RE: Palen Solar Power Project, Docket No. 09-AFC-7
*Palen Solar Power Project (PSPP) Supplementary Information:
Reconfigured Alternative 2 and Reconfigured Alternative 3
Technical Area: Biological Resources*

Palen Solar Power Project (PSPP)

Supplementary Information:

Reconfigured Alternative 2 and Reconfigured Alternative 3

Preliminary Site Plan
Reconfigured
Alternative 3

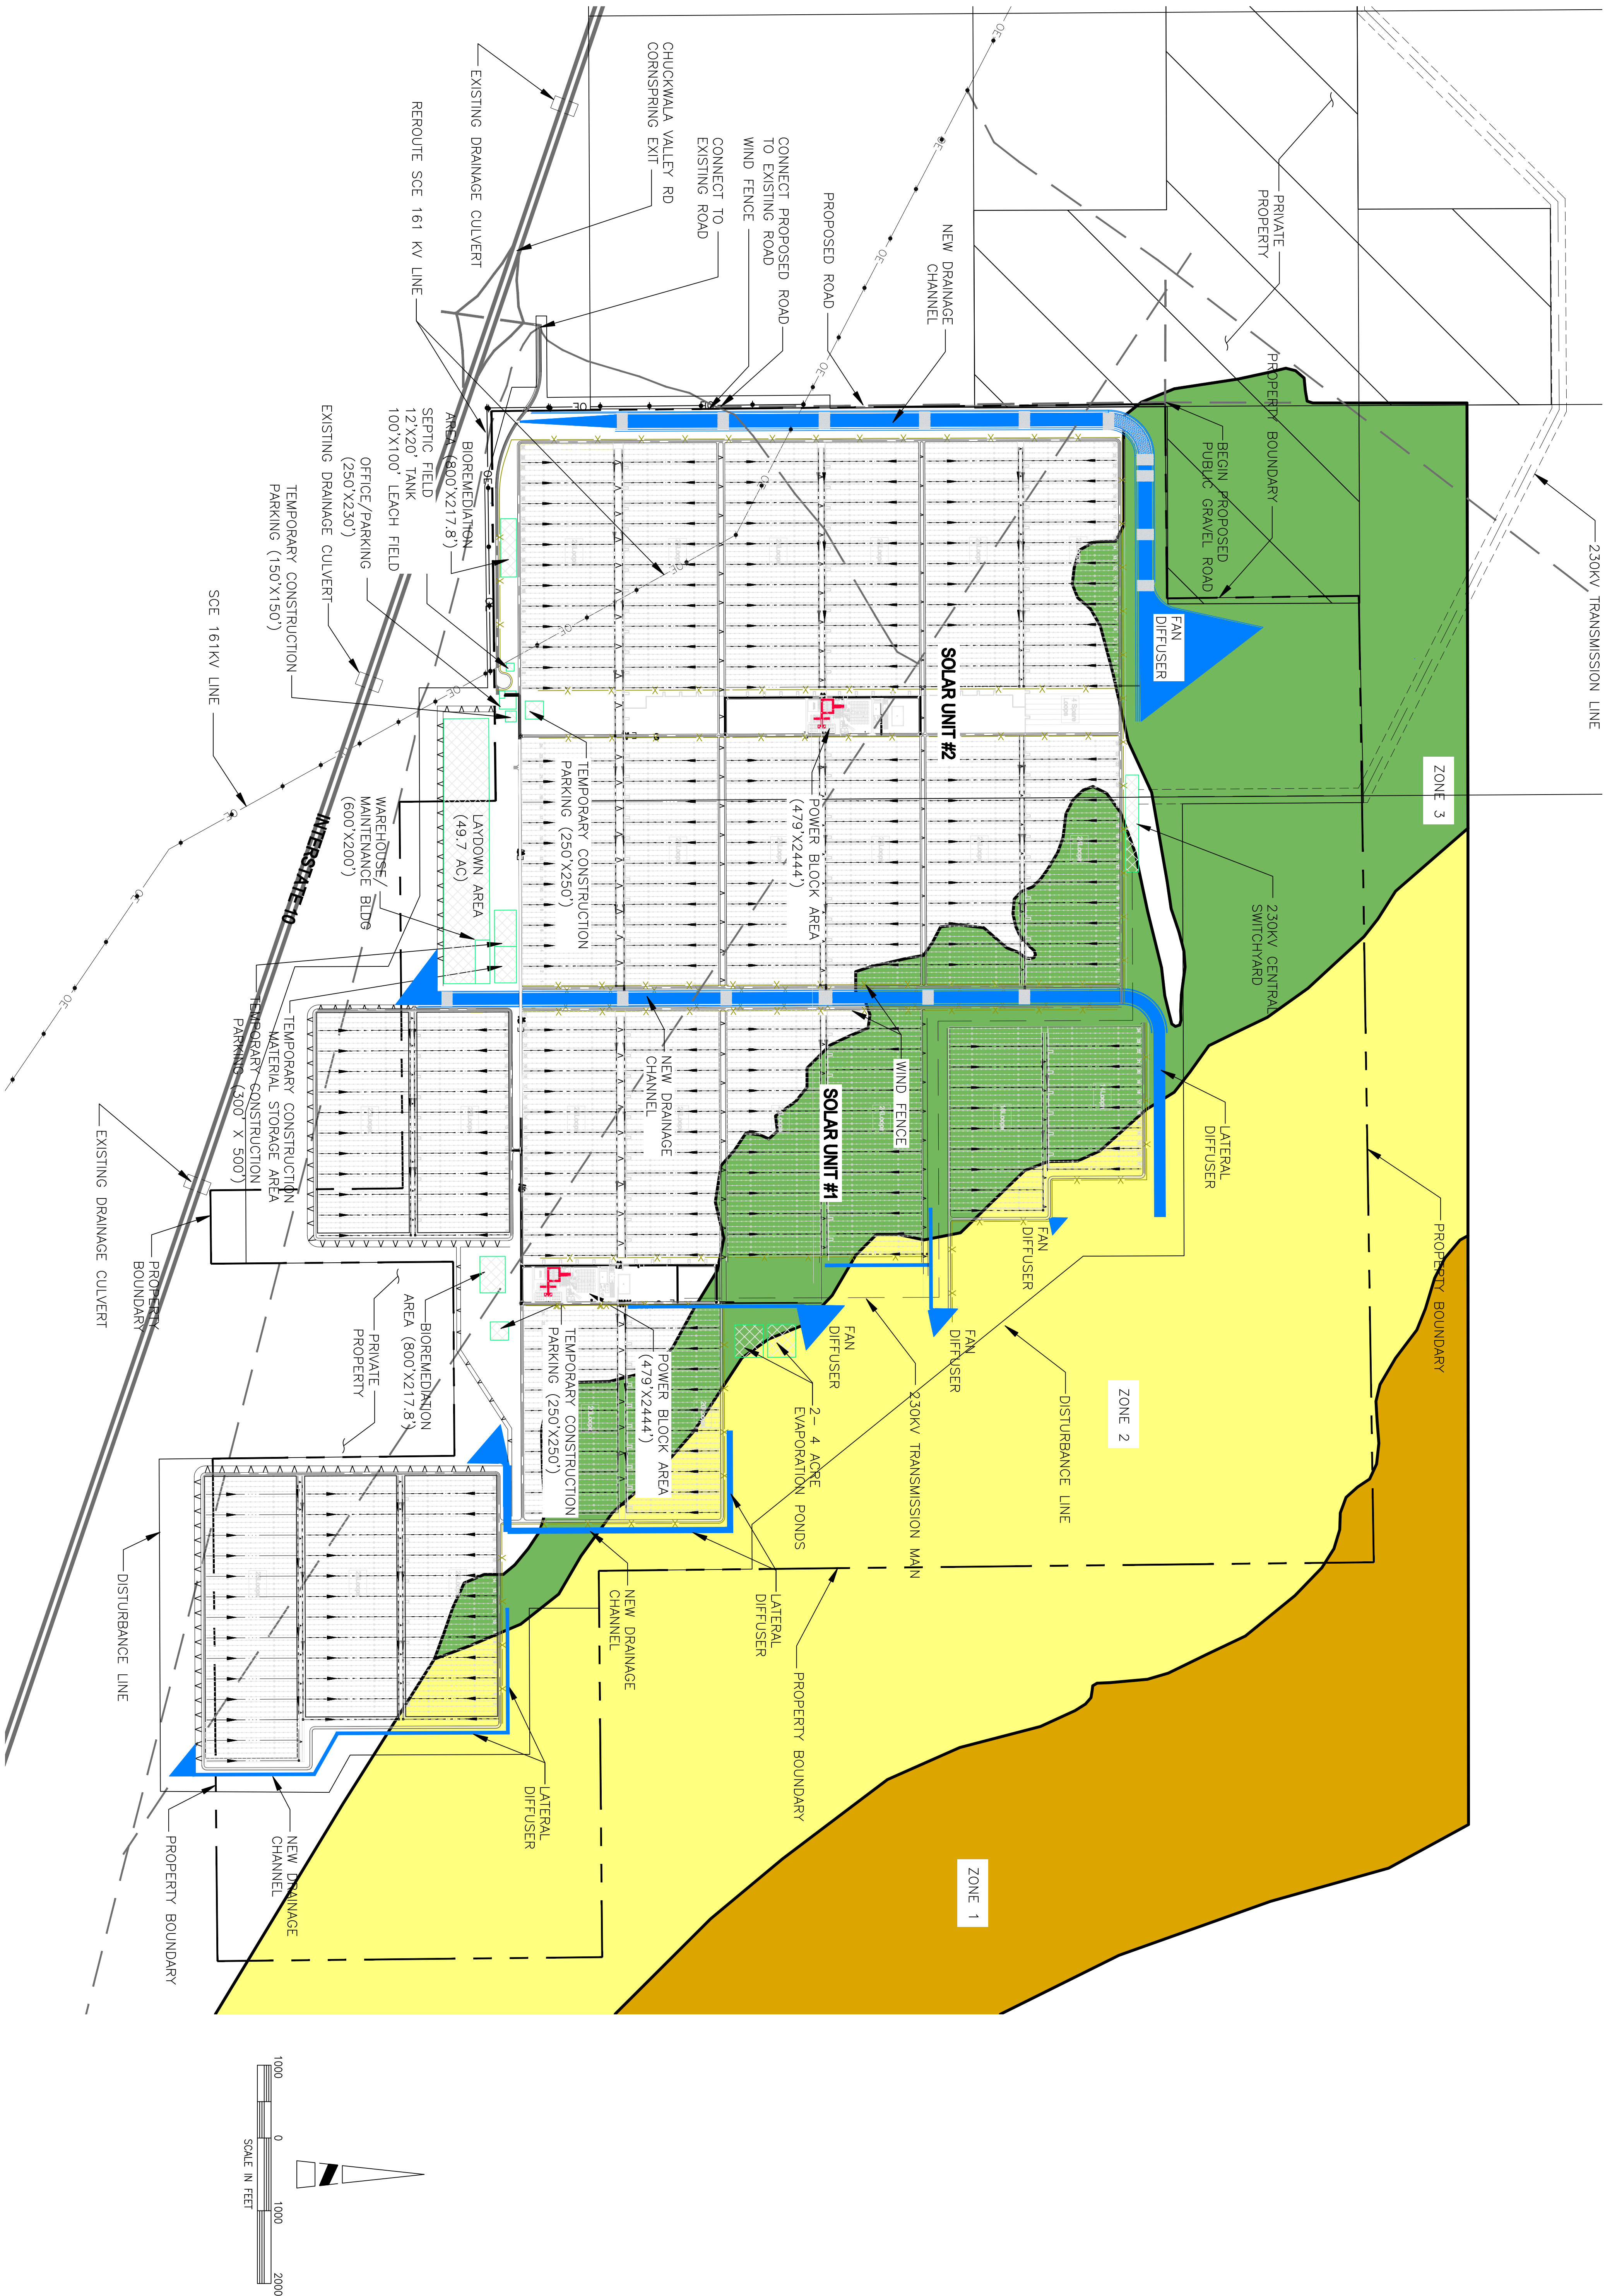
As is the case for Reconfigured Alternative 2, the site plan for Reconfigured Alternative 3 has been conceptually designed to minimize the footprint of the PSPP site (see Figure 2-3) in Zone II of the sand transport corridor. The Alternative 3 site plan generally modifies only the eastern half of the site plan for the proposed Project. The western solar field (Field 2) is unchanged from the proposed Project layout. The Reconfigured Alternative 3 solar field arrangement in the eastern field (Field 1) has been geometrically adjusted into a non-rectangular arrangement, which is less than optimal from an operational perspective, but the proposed arrangement has been evaluated and adjusted to minimize the resultant operational inefficiency. The Alternative 3 site plan has relocated 120 solar loops from the northeast portion of the proposed Project to an area south of the proposed configuration that was previously not used for the Project design. This new area south of the proposed Project footprint is public land managed by BLM. However, this alternative would require adjustment of the boundaries of the BLM Right-of-Way (ROW) because it includes land not currently included in the proposed ROW.

The Reconfigured Alternative 3 site plan consists of two solar plants with associated equipment (solar fields, power blocks, bioremediation areas, as well as a switchyard and transmission lines, and other ancillary facilities such as a warehouse/laydown yard, administrative office area, etc.). The Central Switchyard location is unchanged from the proposed Project. . The administrative office area for the Reconfigured Alternative 3 site layout has not changed, nor has the access to the overall PSPP site. The location of the

warehouse/laydown yard has shifted approximately 3,000 feet to the west, but the size of the warehouse and the functional use of the space is the same as the proposed Project.

The western solar field (Field 2) consists of 288 solar loops and one 250 MW power block along with associated internal infrastructure, drainage channels, and roadway network. This solar field is entirely unchanged from the proposed Project. The eastern solar field, (Field 1), has been partially reconfigured from the proposed Project and consists of 288 solar loops, and one 250 MW power block along with internal infrastructure, new drainage channels, and new maintenance roadway locations. The technology and equipment of the solar field s (solar mirrors, HTF system, and associated infrastructure), are unchanged from the proposed Project. There are no changes to the power block equipment layout associated with Field 1 but the entire power block has been shifted south by approximately 2,700 feet. The evaporation ponds for Field 1 of Reconfigured Alternative 3) are unchanged in terms of function and size, but, they have also been relocated slightly south and east of their location under the proposed Project. The Field 1 bioremediation area is also unchanged in terms of function and size, but it has been relocated to the mid-southwesterly portion of the solar field.

Other Project elements that are different for Reconfigured Alternative 3 and the proposed Project are elements whose configurations are based on overall site geometry, such as internal site utilities and maintenance roads, specifics of site grading and drainage design and the boundaries of the overall disturbance area. The overall disturbance area for Reconfigured Alternative 3 would be 4,328.8 acres

Although the layout of facilities is different for Reconfigured Alternative 3 than for the proposed Project, the total area occupied by solar facilities is essentially unchanged. As noted earlier, the layout of the reconfigured alternative is not as efficient operationally as the proposed Project, and there likely would a very small increase in the total length of maintenance roads and some internal utility lines, and Project fencing. However, it should be emphasized that these changes are very minor.

The grading and drainage detailed design for Reconfigured Alternative 3 will be slightly different from the proposed Project, but the drainage concept and the grading approach will be same. The drainage plan for Reconfigured Alternative 3 site includes the West Channel and the Central Channel essentially unchanged from the proposed Project. The West Channel is completely unaffected by this alternative; the Central Channel is approximately 5,500 feet shorter than in the proposed Project Plan, but the width and depth of the channel will remain unchanged and the flow in the channel is also anticipated to be very similar to the proposed Project. In addition, the Central Channel lateral diffuser has been replaced with a fan diffuser in this alternative due to the fact that the release point for the drainage water occurs at a location where the fan spread of the pre-development flow is narrower.

The East Channel will be approximately 1,000 feet longer than for the proposed Project, and the lateral diffuser at the end of the East Channel has been extended approximately 1,200 feet to disperse flows from the solar fields. The additional length of the East Channel will have negligible effect on the peak flows and volumes, and these flows from the upstream areas to the downstream areas will be maintained just as they were in the proposed Project. Under Reconfigured Alternative 3, one additional drainage channel has been added to the southeast side of the PSPP site to intercept off-site drainage flows. This channel will be engineered in the same fashion as the other channels so that the upstream flow is directed to the same general downstream discharge area as the pre-development flow. Two additional on-site peripheral channels and three fan diffusers have been added in the mid-northeastern portion of the Reconfigured Alternative 3 site plan to direct on-site flows to the appropriate downstream area. These changes should not require new conditions of certification beyond those proposed in the SA/DEIS.
